■ SEAT

1. Rear No. 1 Seat

Rear No. 1 Seat Frame

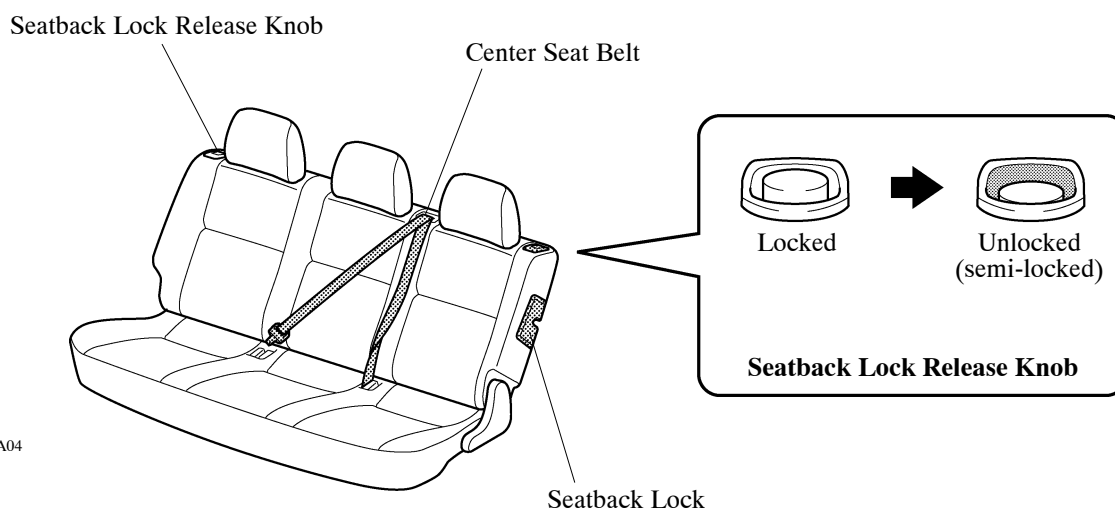
Along with the change made to the center seat belt, the seat frame has been reinforced.
